**REMARKS**

The Applicants respectfully request further examination and reconsideration in view of the amendments made above and the comments set forth below. Claims 1-33 were previously pending in this Application. Within the Office Action, Claims 1-33 have been rejected, and 5 Claims 1, 5, 6, 7, 16, 20, and 31 have been amended. Claim 2 has been canceled. Claims 1, 3-33 are now pending in this application.

Fig. 1

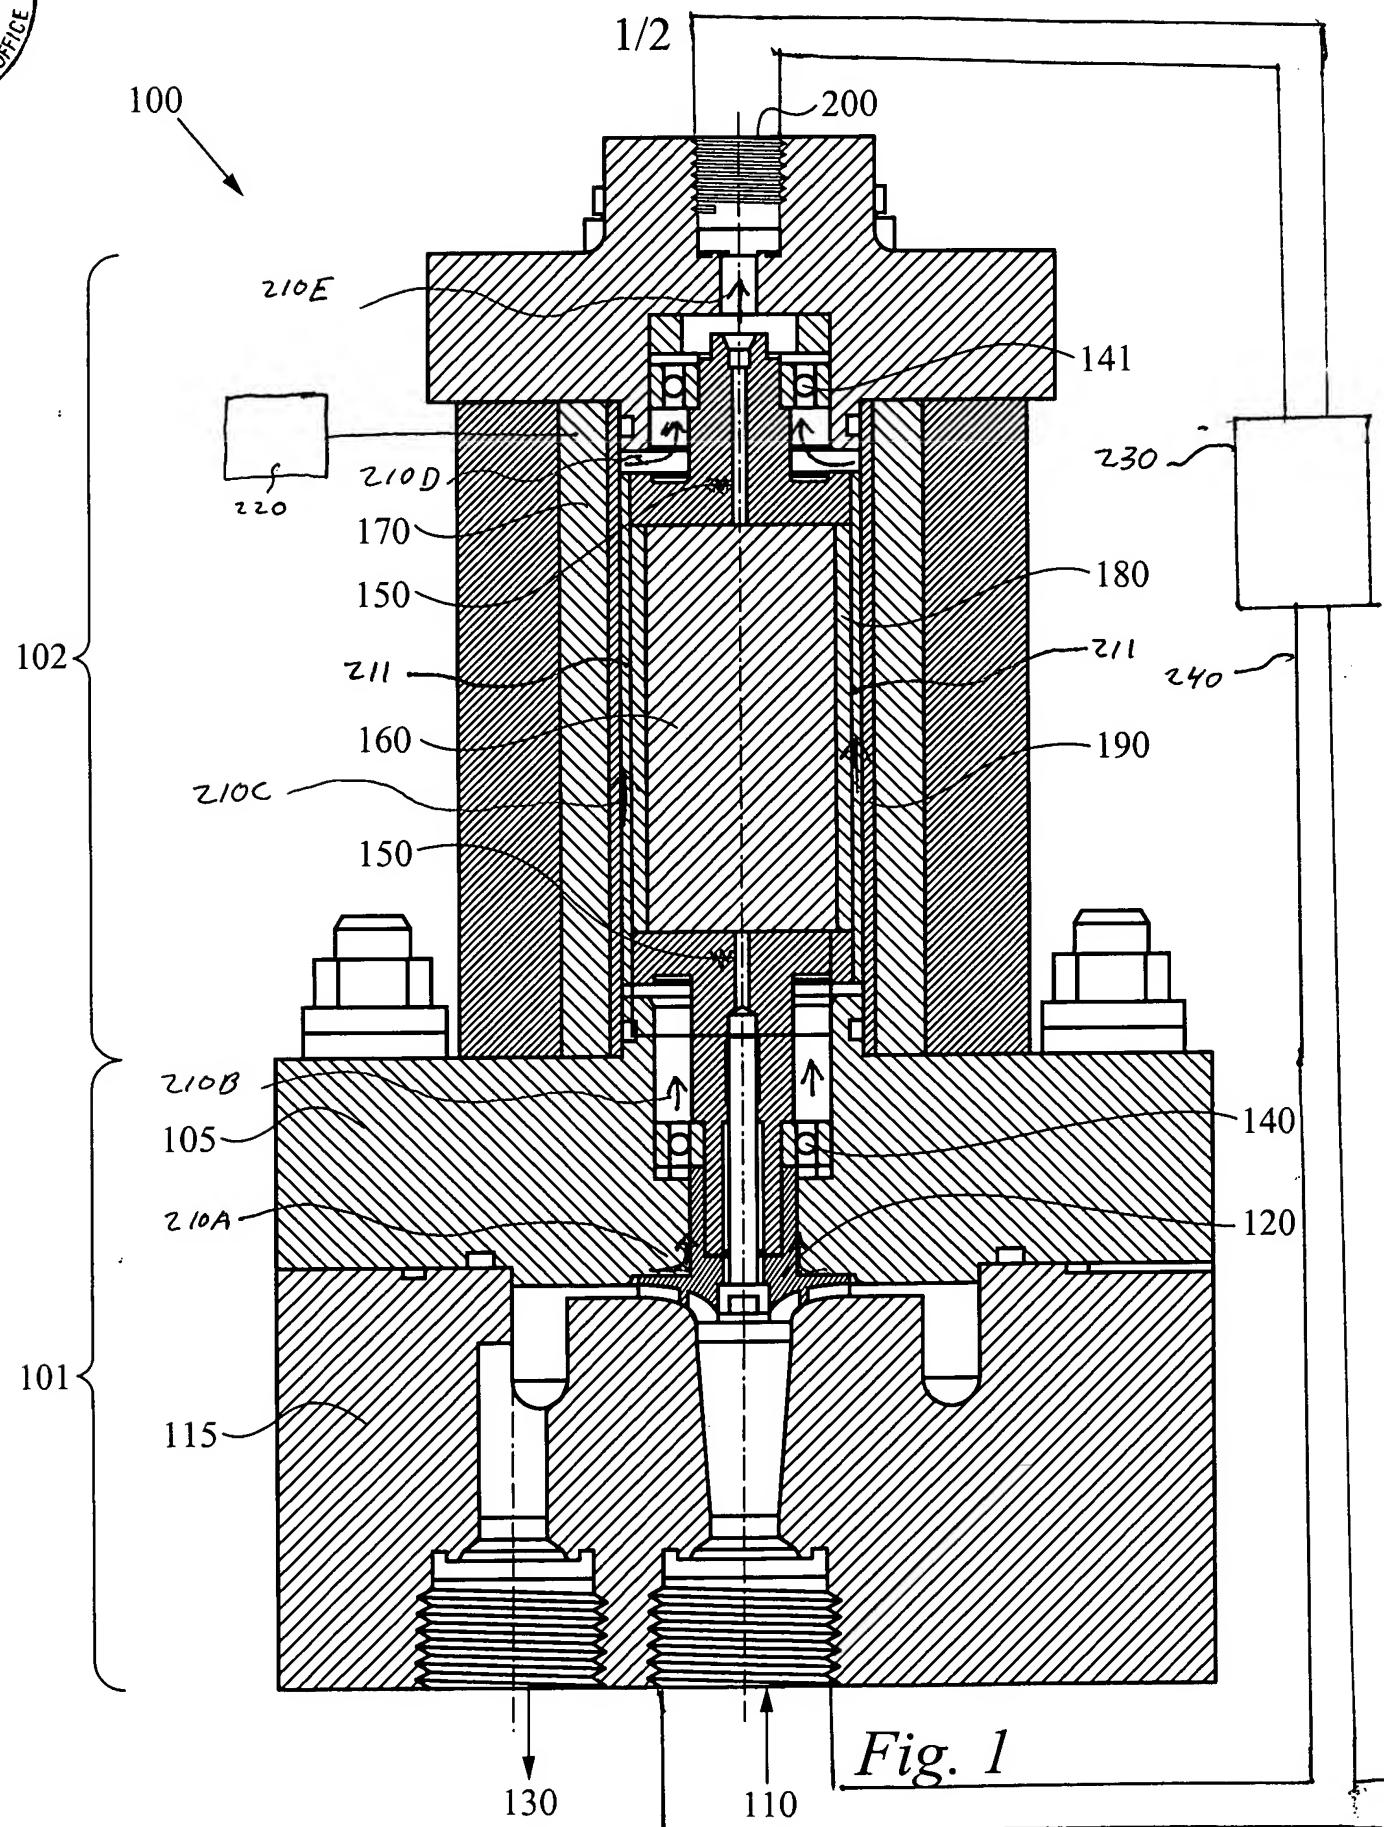
Within the final Office Action, the drawings were objected to under 37 CFR 1.83(a) 10 because they fail to show “every feature of the invention in the claims”. Specifically, the electrical controller of claim 3, the bearings of claim 6, the filter of claim 16, and the alternative flow path of claim 20.

Fig. 1 is amended to show the electrical controller 220 of claim 3. The electrical controller element does not constitute new matter. Within the Summary of the Invention, page 2 15 lines 24-25, of the patent application specifies the electrical controller element. Additionally, the Detailed Description of the Invention of the patent application, page 4 lines 25-27 and page 5 line 1, further specifies the electrical controller. Accordingly, the drawings now shows the electrical controller element of Claim 3 and is in a condition of allowance.

The bearings mentioned in Claim 6 are disclosed in Fig. 1 as elements 140 and 141. 20 These elements do not constitute new matter. The bearings are specified within the patent application on page 2, line 25 through page 4, line 2 and on page 6, lines 1-12. Accordingly, the drawing shows the bearing elements of Claim 6 and is in a condition of allowance.

Fig. 1 is amended to show the filter element 230 of Claim 16. The filter element does not constitute new matter. This element is specified within the patent application on page 6 lines 24. 25 Accordingly, the drawing shows the filter element of Claim 16 is in a condition of allowance.

Fig. 1 is amended to show the alternative flow path 210A, 210B, 210C, 210D, and 210E. These arrows show the path of the fluid along the alternative flow path. This path is specified in the patent application on page 3 lines 22-23, page 6 lines 14-15, page 6 lines 20-22. Accordingly, the drawing shows the alternative flow path specified in Claim 20 and thus Claim 30 20 is in a condition of allowance.
